DALTON POWER PROJECT

**SUBMISSION IN RESPONSE TO THE ENVIRONMENTAL ASSESSMENT OF THE  
AGL DALTON POWER PROJECT**

**DEPARTMENT OF PLANNING COUNCIL - MPI0\_0035 - EXHIBITION OF ENVIRONMENTAL ASSESSMENT FOR DALTON POWER PROJECT**

AGL Energy Limited proposes to construct a 1500MW gas turbine power plant north-east of Dalton, NSW. You invited the OEH to review the Environmental Assessment (EA), make a submission on the project and provide advice on recommended conditions of approval to the Department of Planning and Infrastructure. I apologise for the delay in responding.

Figure A-2: Radius of 2.5km from the Uranquinty power station and the location of dwellings

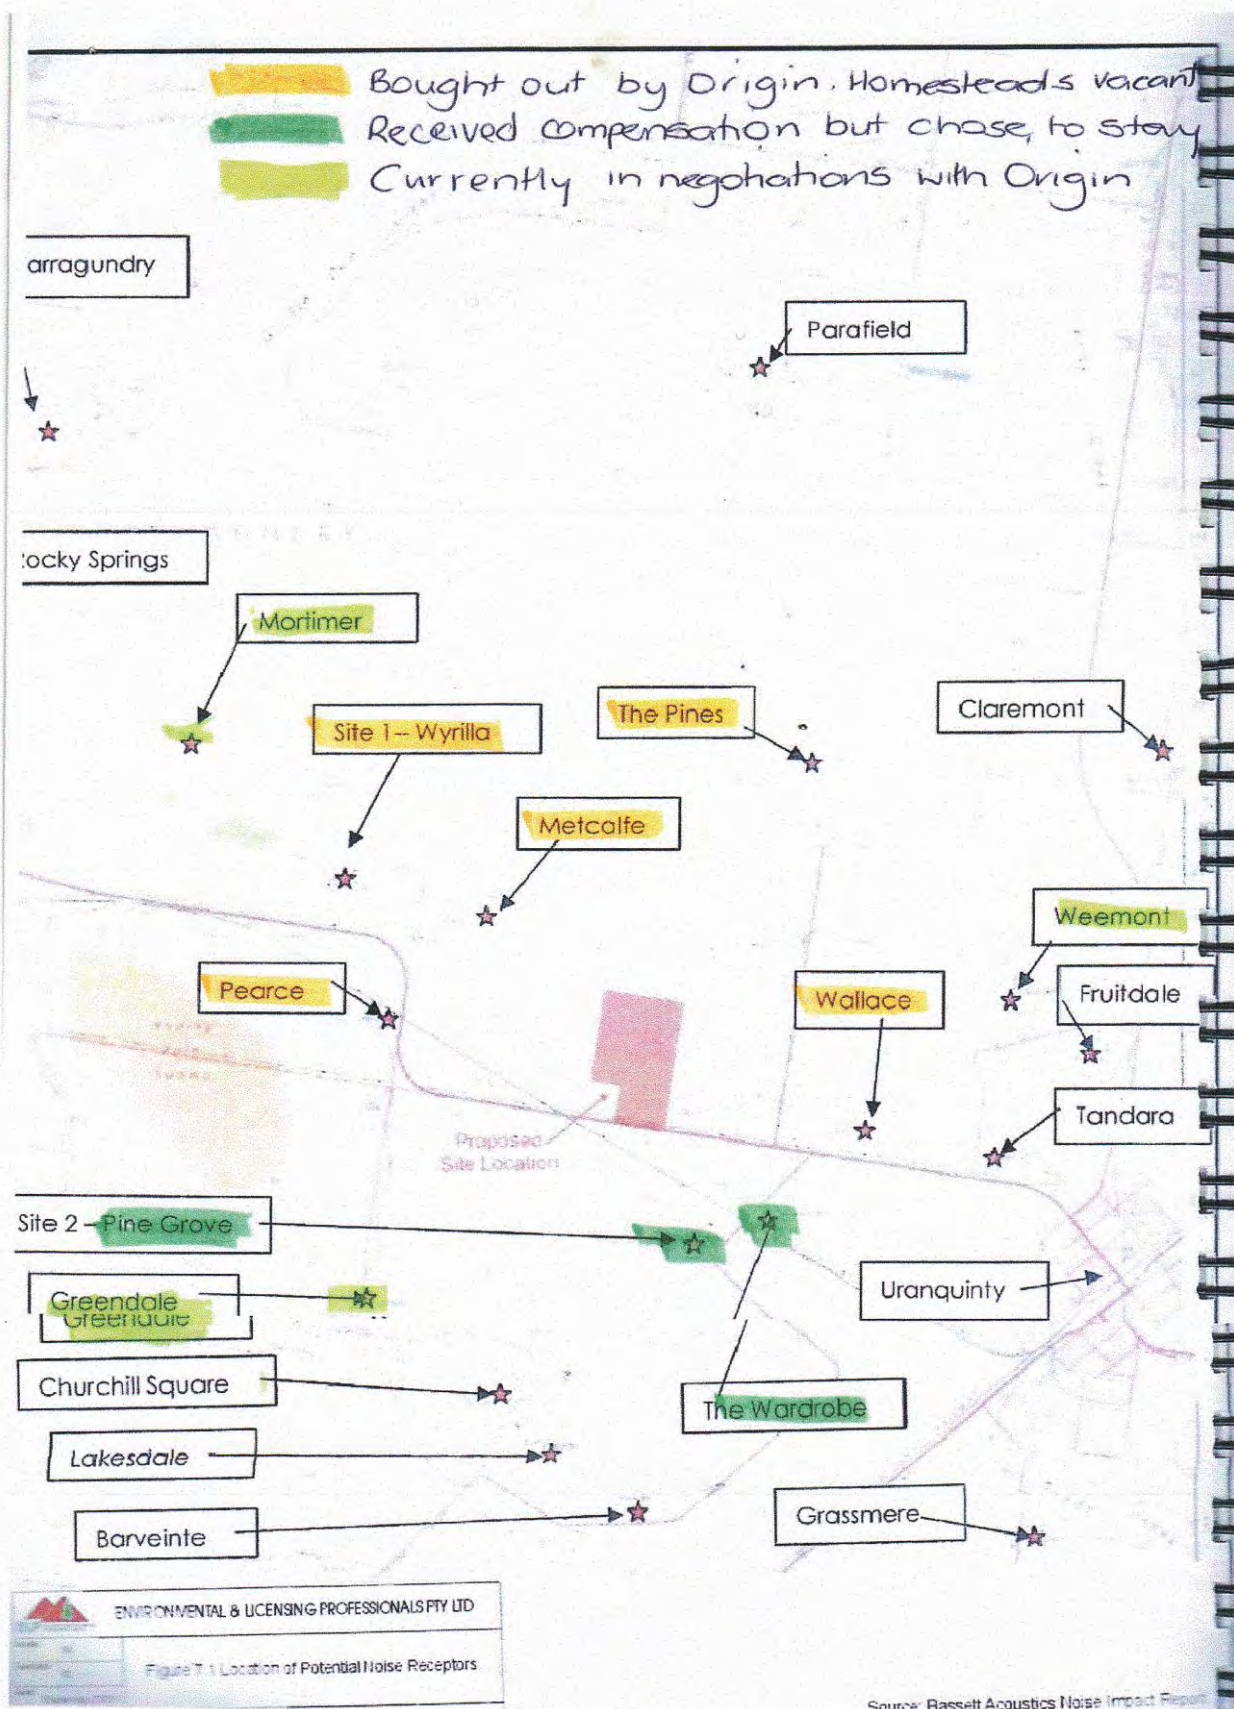
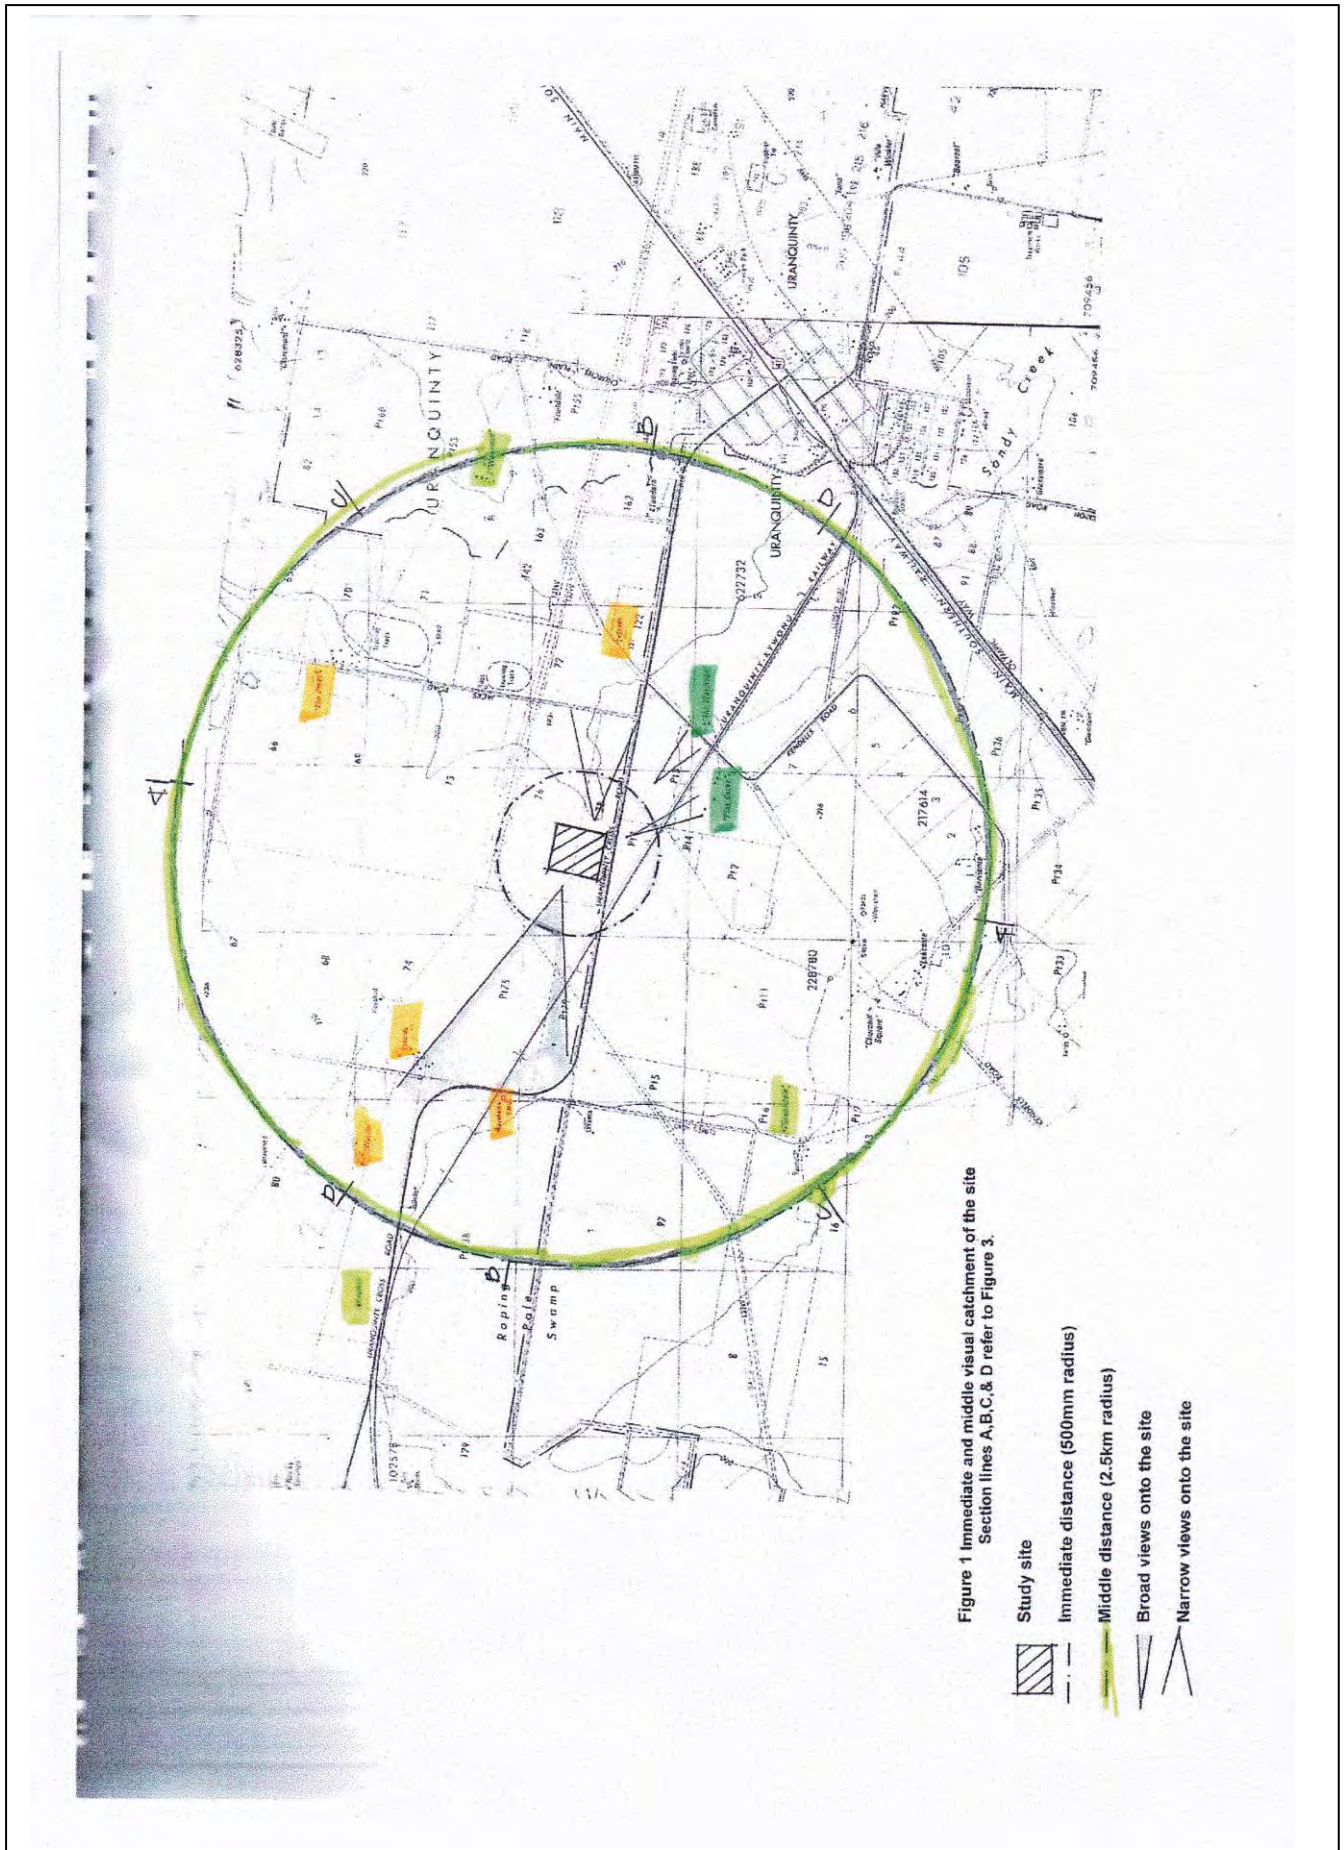
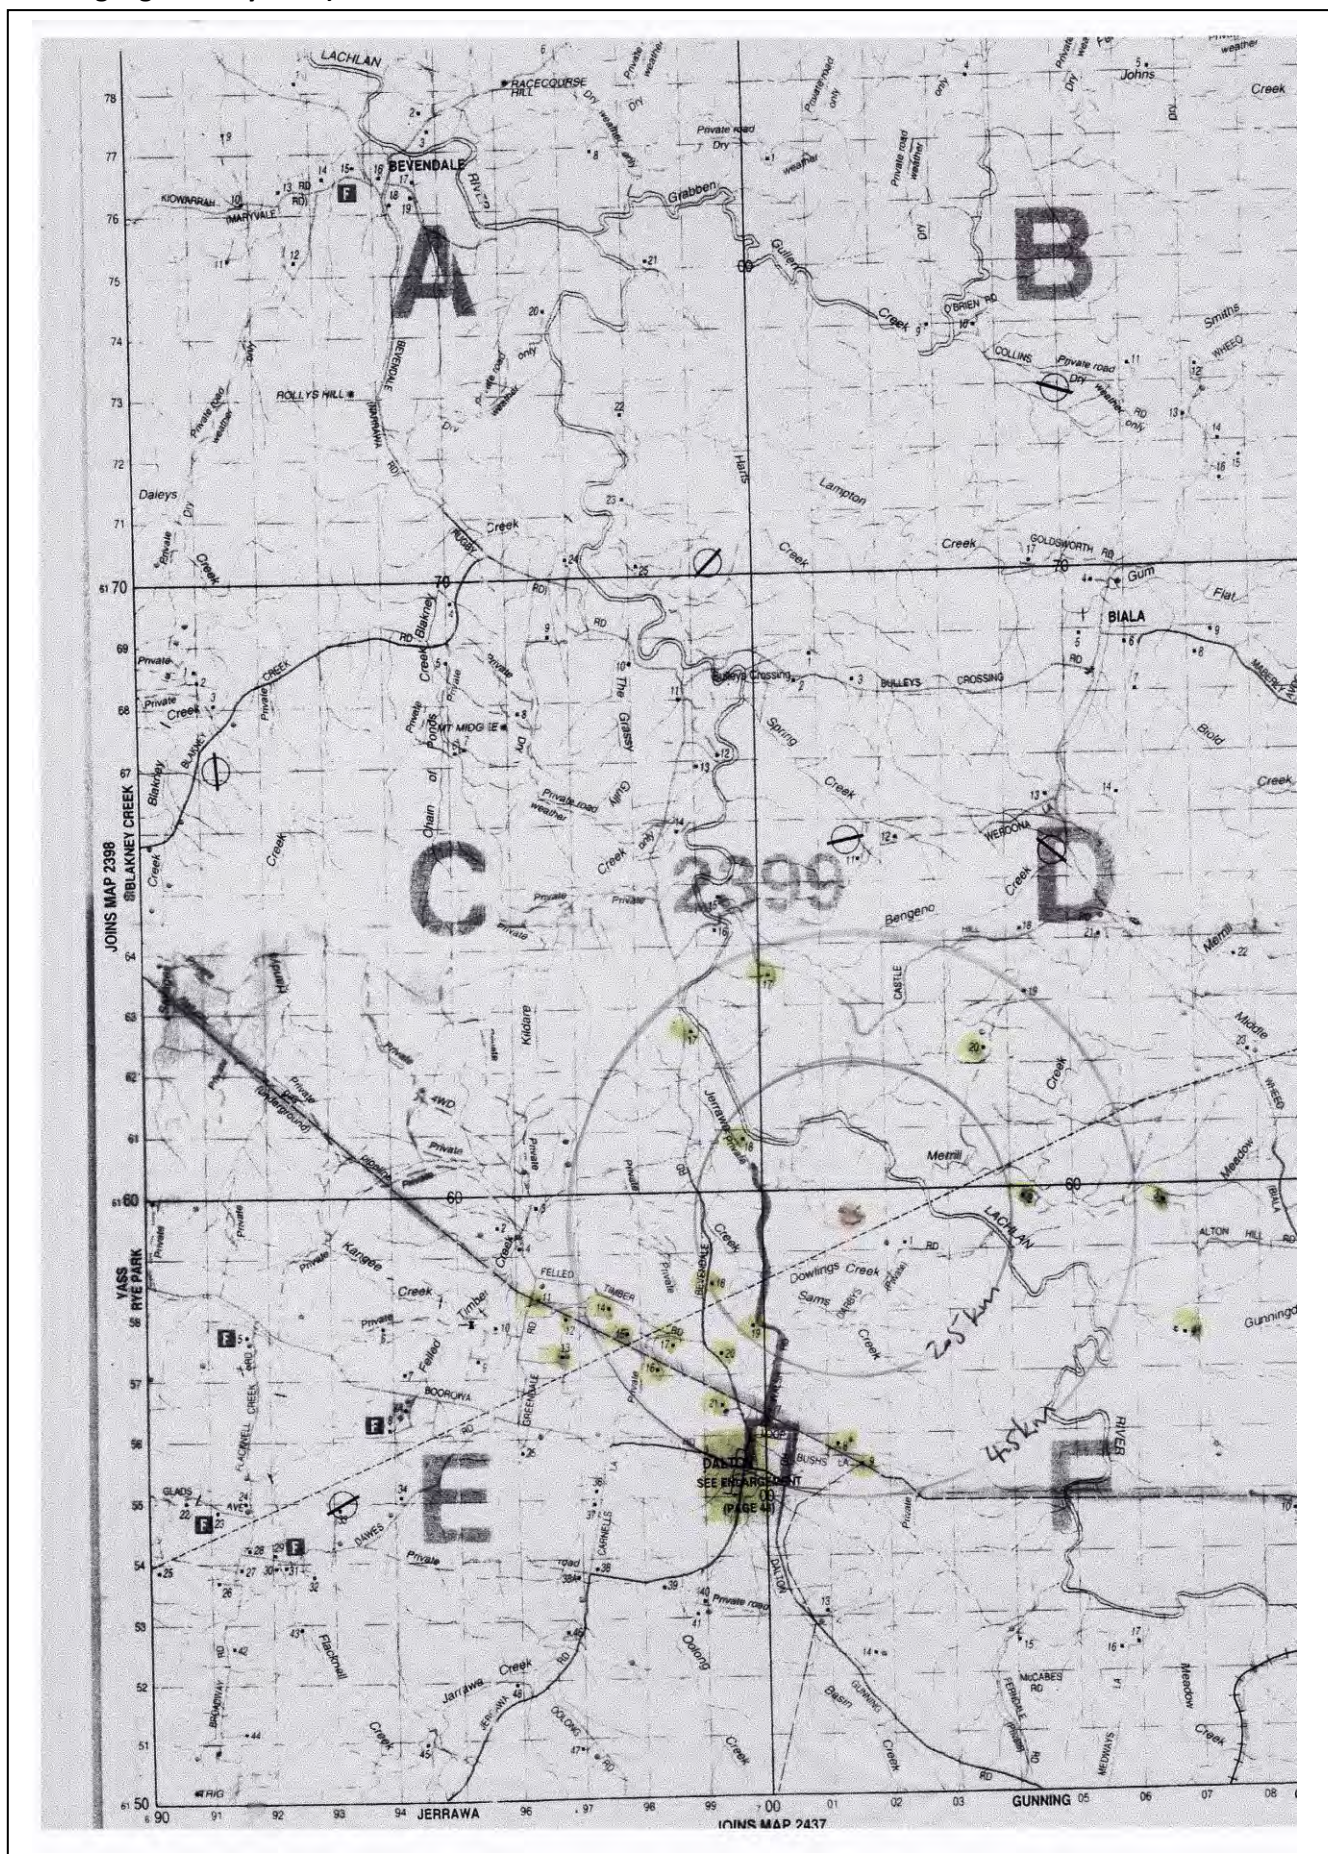
- 5 have been bought out by Origin and left the area (see Figure A-1 below)- Wyrilla & The Pines were 4th generation families;
- 2 have taken compensation payments for the next 5 years with the option to be bought out if the noise levels cannot be mitigated;
- 2 are currently in negotiations with Origin.

In Figure A-2 the circle with a 2.5km radius shows the location of residents relative to the Uranquinty power station.

### 210MW GAS TURBINE POWER STATION AND DATA STORAGE CENTRE, TUGGERANONG

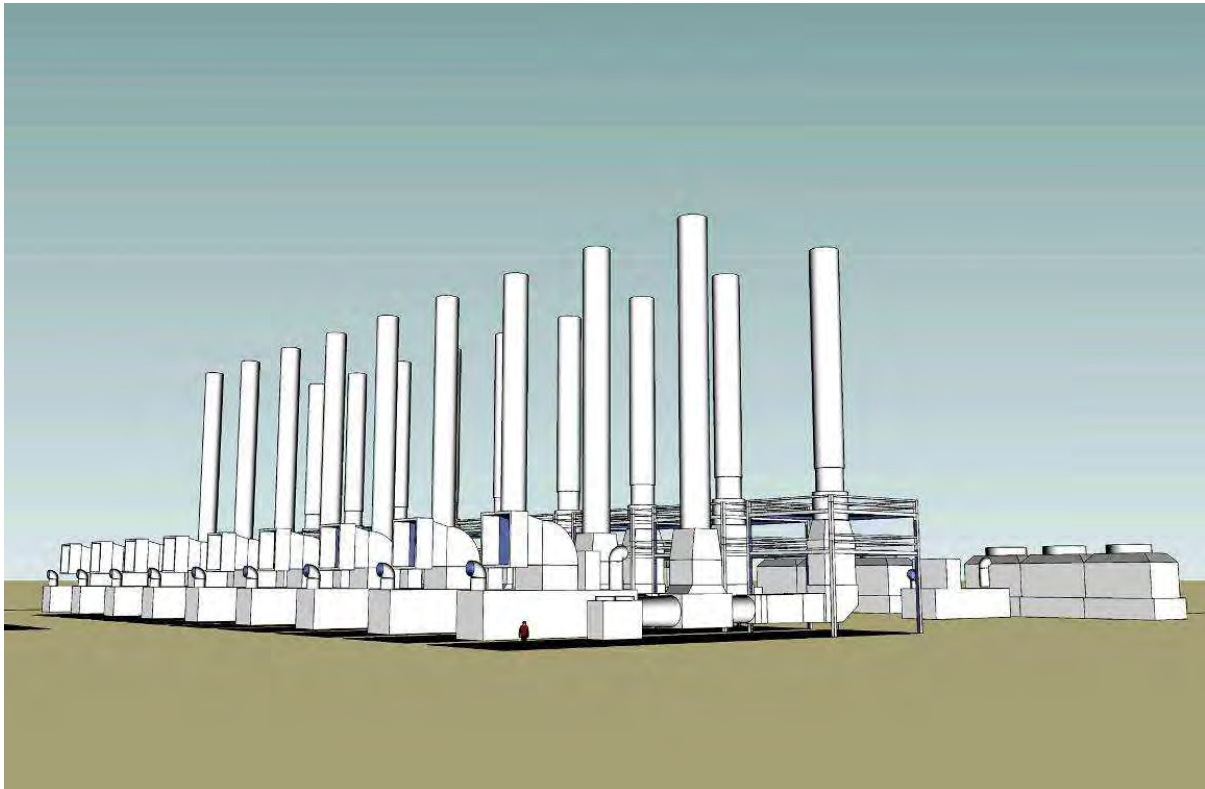
- 3.2 No artist impression or elevation drawings of the proposed development.** Apart from the wrong image on the front cover, there is no artist impression of the power station included in the EA. While a plan of the site has been included, showing dimensions roughly 500 m by 700 m, no elevations showing reference levels are provided. Some distant views are included as part of the visual assessment, but nothing is provided to show the bulk and scale of the structure with reference to the topography. An artist's impression of the much smaller 210MW Tuggeranong power station is included here in Appendix C of this submission.

The stack heights in the submitted plan for Tuggeranong were 35m. The proposed height at Dalton is 35m for Stage 1 and 46m for Stage 2.
